**PCN: V19-003-SD475420-0A**

## Product Change Notice

Issue Date: 20<sup>th</sup> November 2019

Manufacturing site relocation.

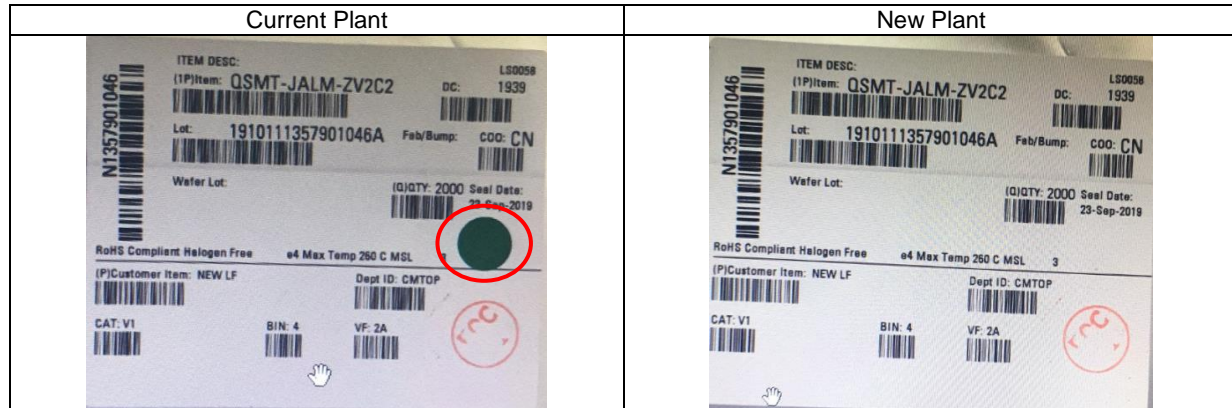
After change, all parts from of current plant will be indicated on mother label as below:
